FTAA-2504-1055 - Rangitoo-puni Application

Maven Response

1.1 Overview and General Approach

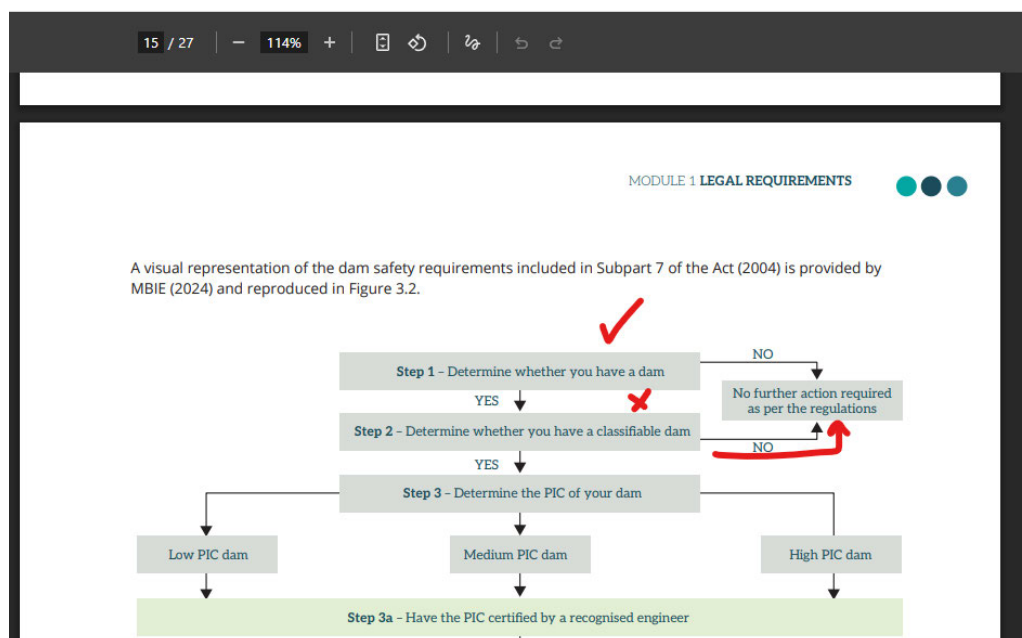
Please refer to the appended memorandum from ENGEO. Collectively, we note that the dam is not a classifiable dam under the *NZSOLD New Zealand Dam Safety Guidelines* (2024). This is because neither dam features a total volume (when measured to the dam crest) of 20,000m³.

For Culvert 1-1, this assumes the 100-yr culverts are blocked and ultimately overtops the crest in the accessway (JOAL 1), for Culvert 7, this is to the 100-yr spillway level, noting there is not a 100yr culvert in the design. Please refer to additional plans C485 PN 147007, C481-6-1 PN 147016 which provide more detailed assessment relative to the volumes and crest heights of both structures.

The below figure outlines a clear flow diagram of how dams are classified and when a PIC assessment is needed. Resultantly, no PIC is required.
